11416, 11420, 11419 and 11423 - 78 Avenue NW

To allow for two transit oriented mid-rise residential buildings with limited commercial uses fronting on public open spaces.

Track Changes of Proposed DC2

Waste Services

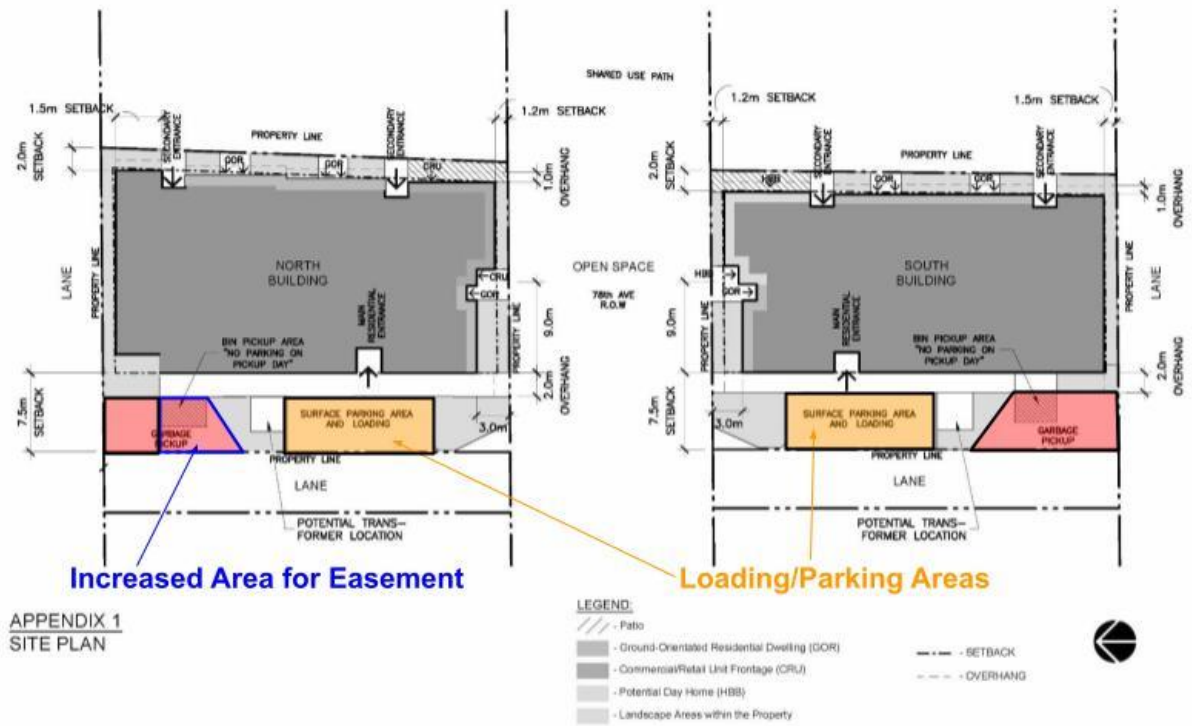
The revised application includes reconfiguration of the loading space, easement and waste collection areas on the west side of the site (see image below).

The loading zones for both buildings have been removed from the easement areas, thus reducing potential turning conflicts for waste servicing vehicles. To accommodate this change, loading space areas have been relocated to the surface parking areas for the purposes of both loading and parking needs.

The easement area for the north building has been expanded to the south. This creates additional manoeuvring turns for waste collection trucks and allows for potential gains in efficiency when collection routes are planned. To ensure turning movements, a condition of the easement agreement requires the waste collection and easement areas to be clear of any obstructions and the DC2 provisions now includes requirements for site signage denoting no parking or loading allowed within these areas. The easement areas for both buildings shall be registered on title for the subject properties as a condition for the road closures.
